**SUBJECT: NEW VEHICLE DEMONSTRATION / DELIVERY HOLD
 Safety Recall 22S47 - Supplement #1**

Certain 2021-2022 Model Year Corsair, 2020-2022 Model Year Escape and 2022 Model Year Maverick Vehicles Equipped with a 2.5L HEV/PHEV Engine Under Hood Fire

**REF: NEW VEHICLE DEMONSTRATION / DELIVERY HOLD
 Safety Recall 22S47
 Dated July 8, 2022**

New! REASON FOR THIS SUPPLEMENT

FIGURE 4

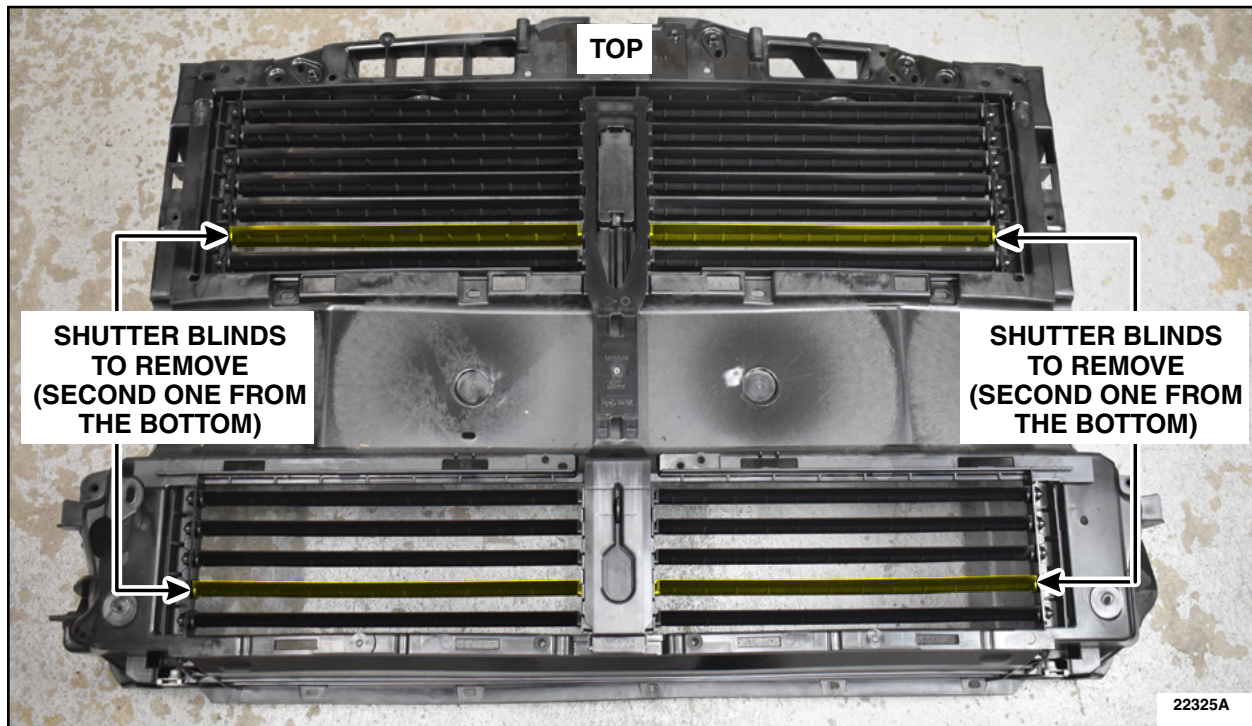
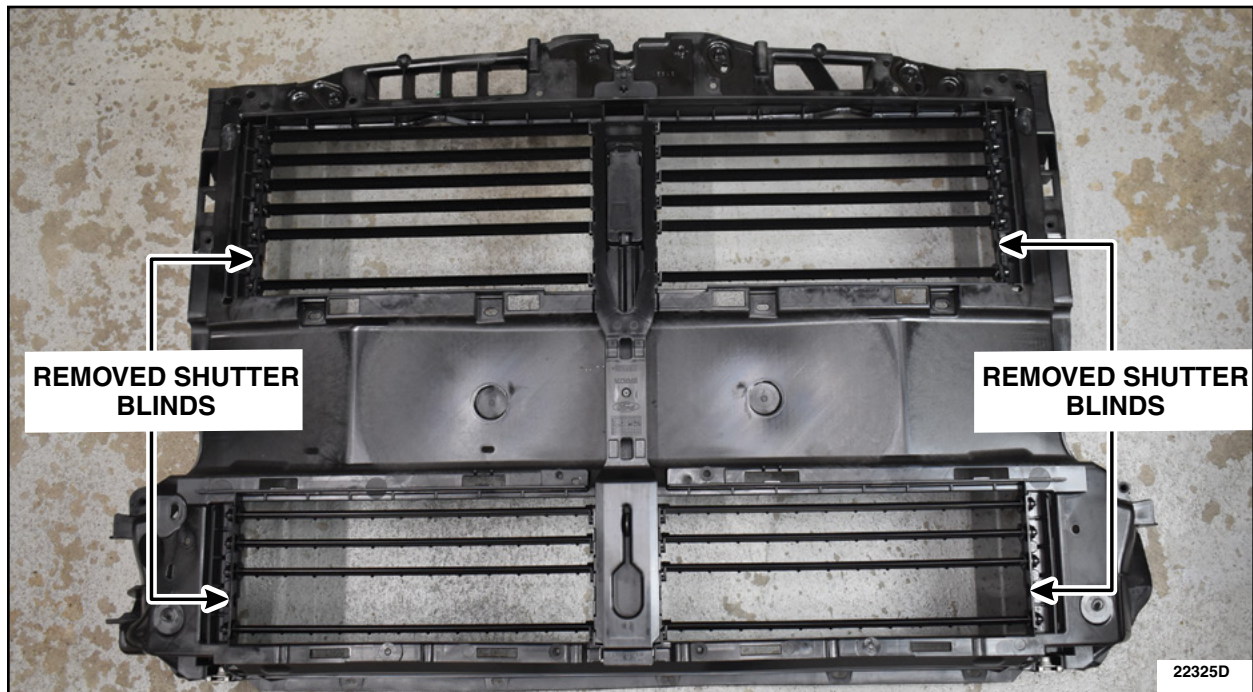
2. Remove the four required shutter blinds. See Figures 1, 2, 3 and 4.

- First, bend the shutter blind at center and pull toward the front of the vehicle, then remove the OUTBOARD side tab from hole in housing.
- Second, pull to dislodge the INBOARD side tabs via pulling toward outboard the side of vehicle and remove the shutter blind.
- Third, verify all remaining shutter blinds move and do not bind.

NOTE: Maverick shutter blinds can be removed through the bumper cover opening.

FIGURE 5

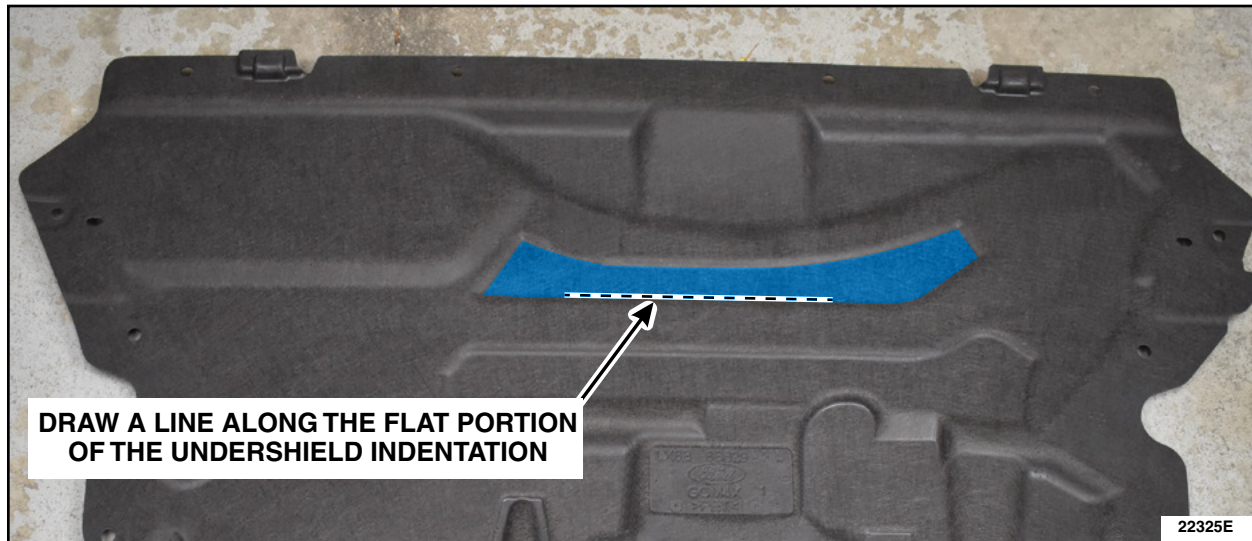
6. Using a liquid paint marker or equivalent, draw a line on the engine front undershield along the flat inner edge of the indentation as shown in Figure 5.

FIGURE 6

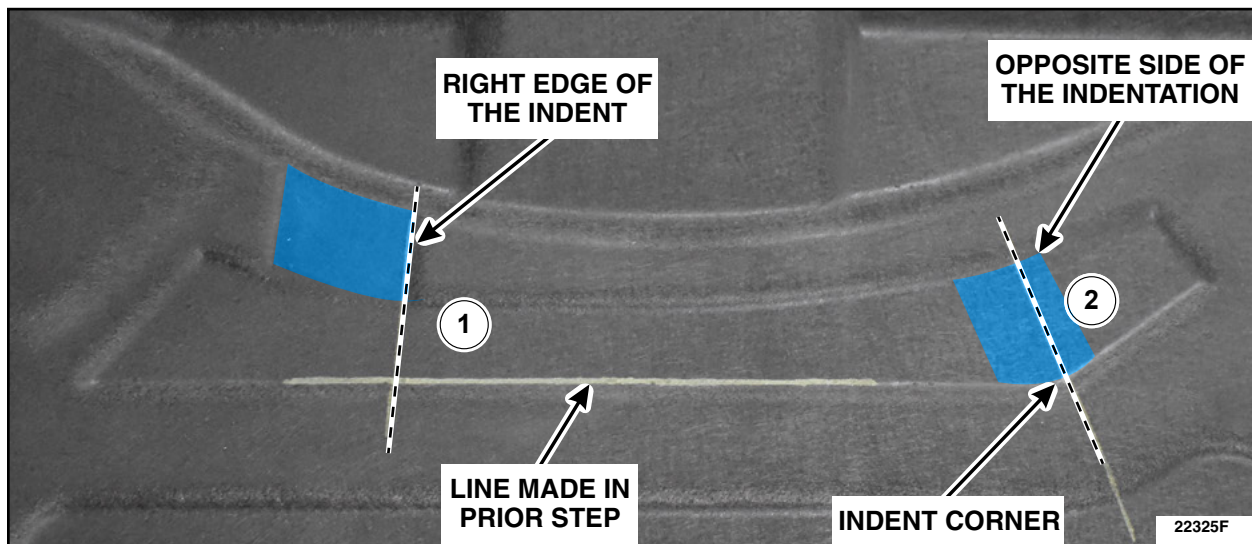
7. Using a liquid paint marker or equivalent and a flat edge, draw a line from the right edge of the indent to the line made in the prior step (1). Draw a line from the indent corner to the opposite side of the indentation (2). See Figure 6.

FIGURE 7

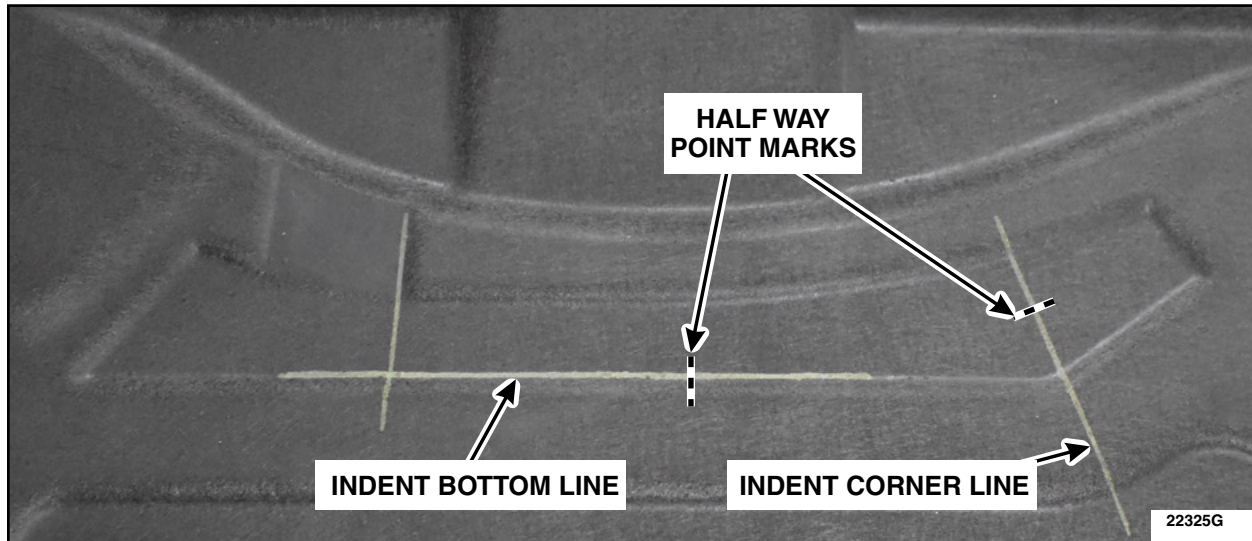
8. Using a liquid paint marker or equivalent, put a mark at the half way point on the indent bottom line and on the indent corner line (right side). See Figure 7.

FIGURE 8

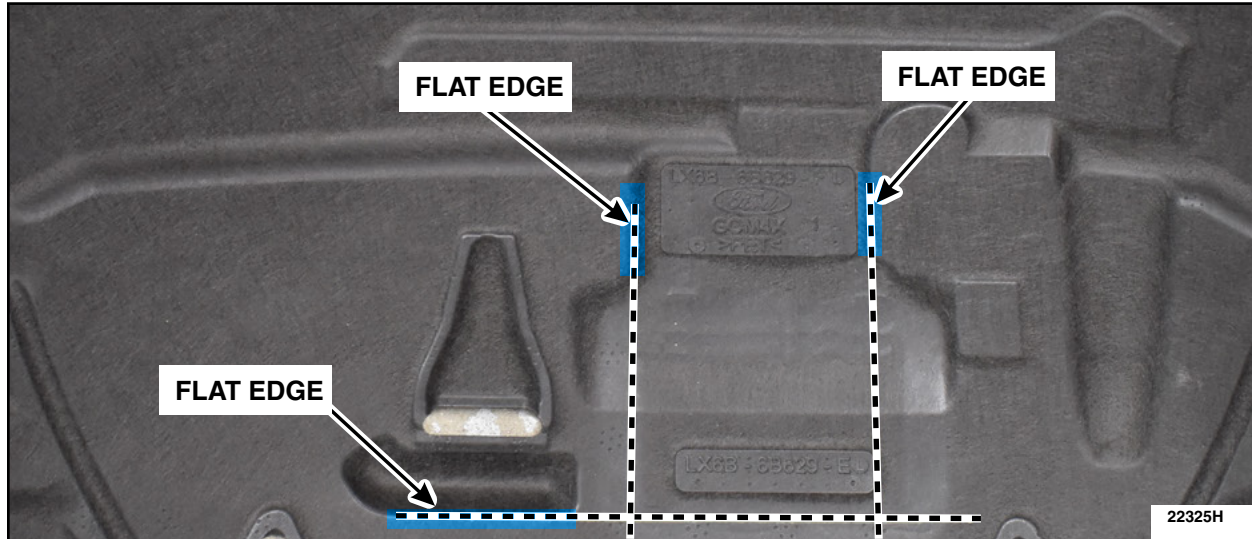
9. Using a liquid paint marker or equivalent and a flat edge, draw 3 lines using the flat side of the indentations shown. See Figure 8.

FIGURE 9

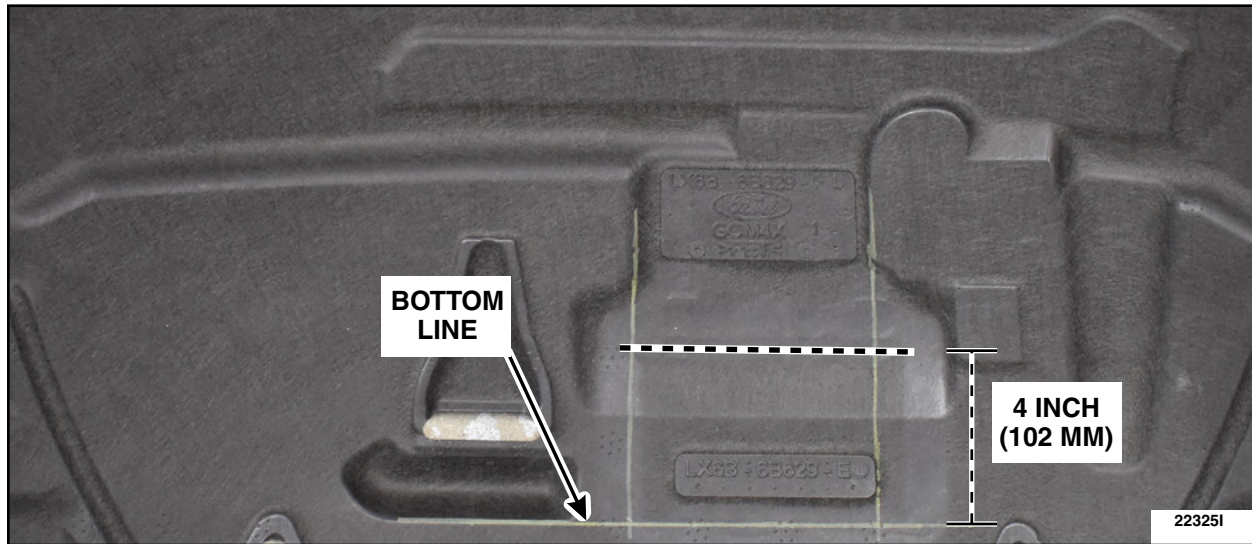
10. Draw a line 4 in (102 mm) up from the bottom line. See Figure 9.

FIGURE 10

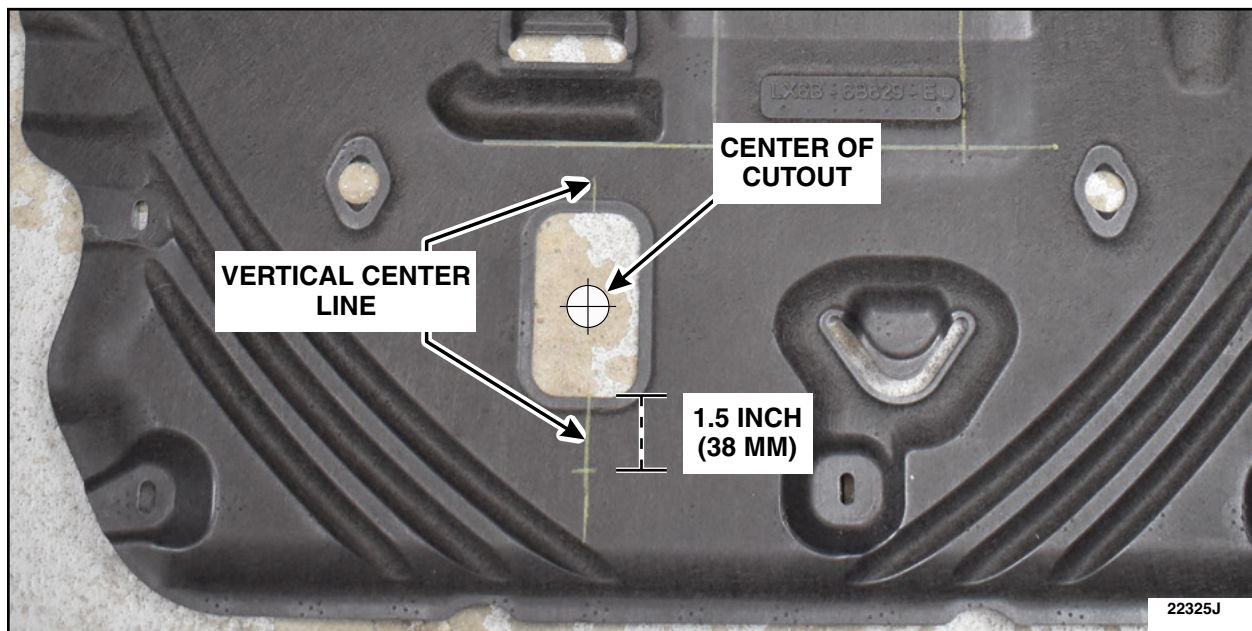
11. Find the center of the cutout and draw a line for vertical center. Measure from the bottom edge of the cut out 1.5 in (38 mm). See Figure 10.

FIGURE 11

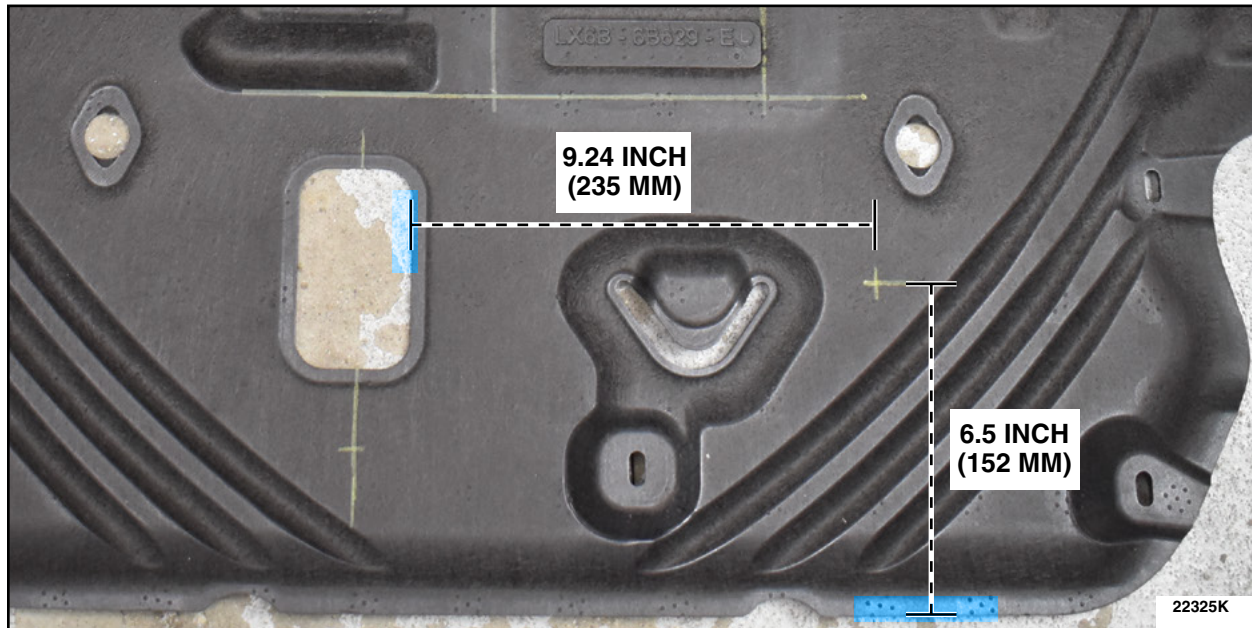
12. Measure 9.25 in (235 mm) from the cut out and 6.5 in (152 mm) from the edge of the shield.
See Figure 11.

FIGURE 12

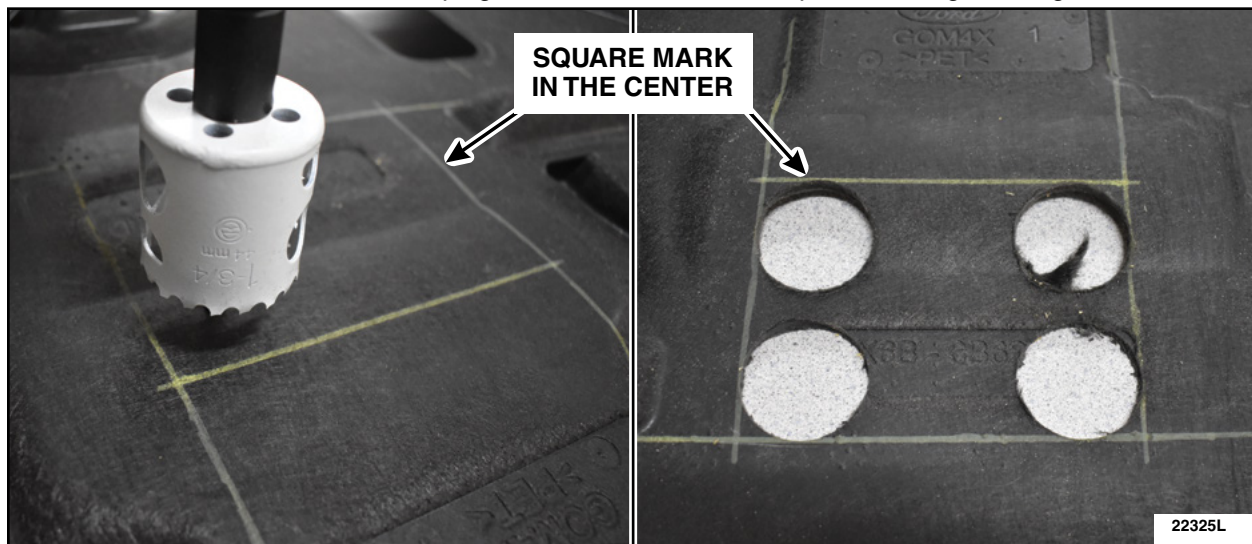
13. On the square mark in the center, using a 1-3/4 inch (44 mm) Bi-Metal Hole Saw with arbor and pilot bit, drill a hole in each corner keeping the hole saw within the square marking. See Figure 12.

FIGURE 13

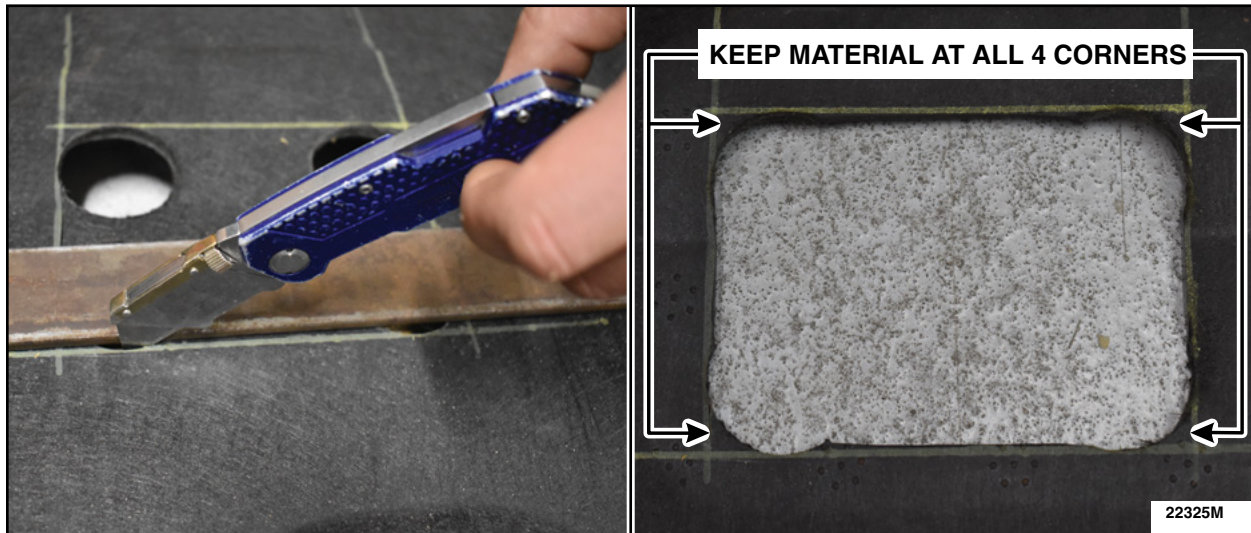
14. Using a straight edge and a utility knife, cut out the underbody shield material left between the 4 holes made within the square. See Figure 13.

FIGURE 14

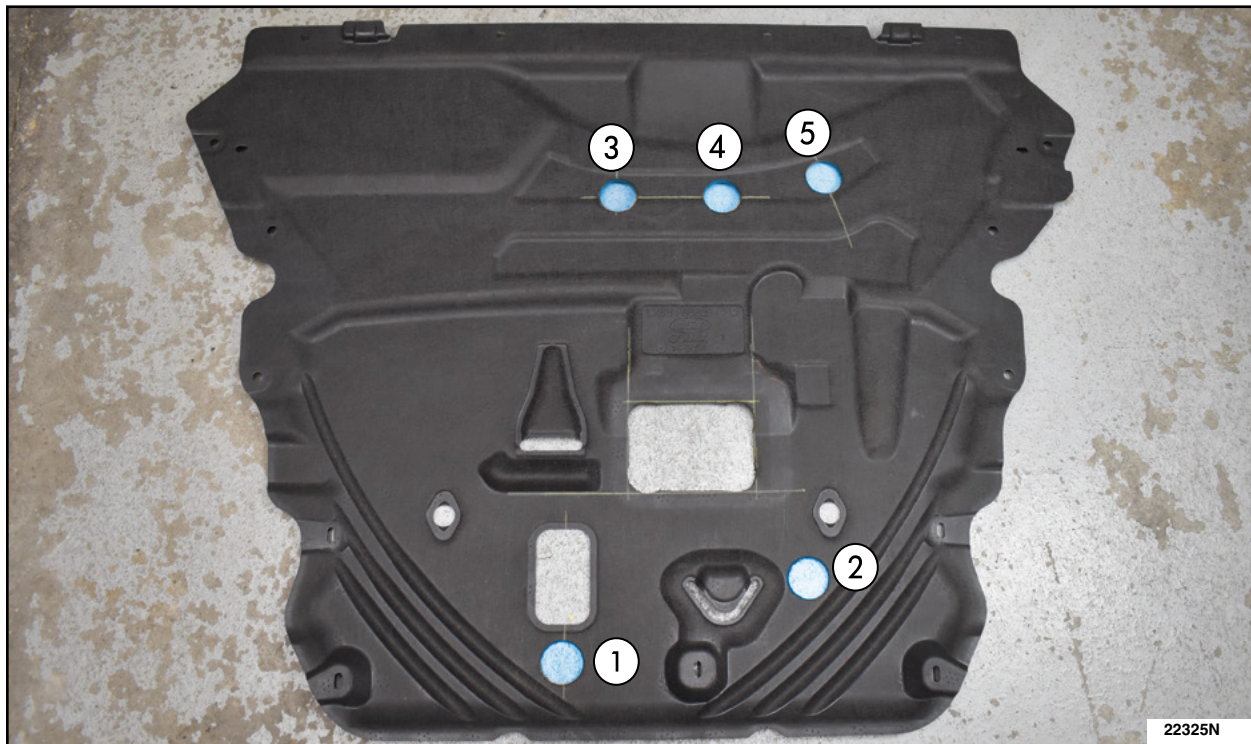
15. Using a 1-3/4 inch (44 mm) Bi-Metal Hole Saw with arbor and pilot bit, drill out the remaining 5 holes. See Figure 14.

FIGURE 15

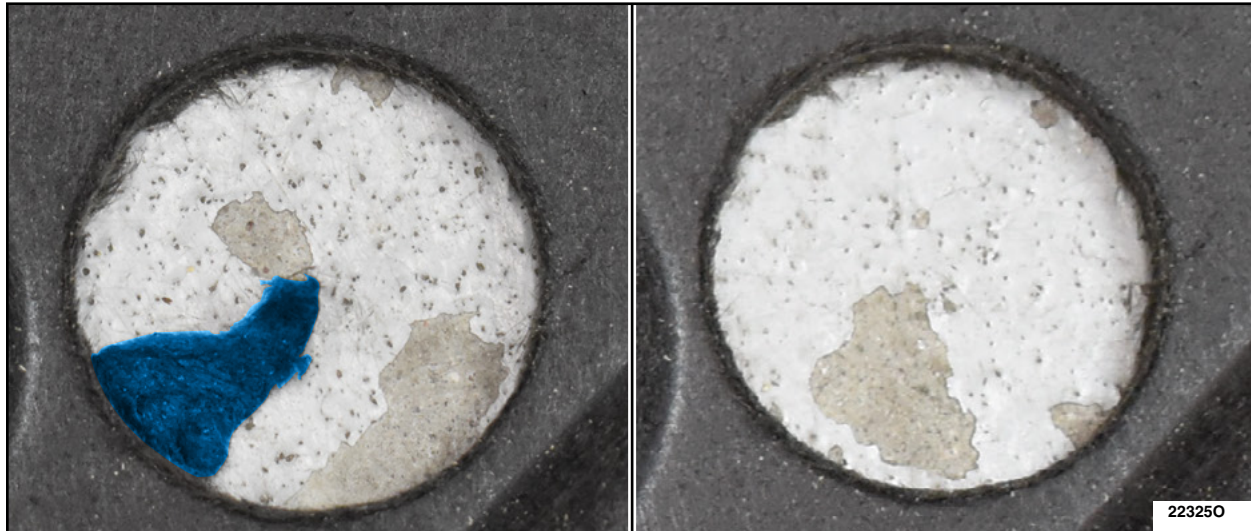
16. Using a utility knife, clean up any burrs and stray pieces of underbody shield material in any holes drilled. See Figure 15.
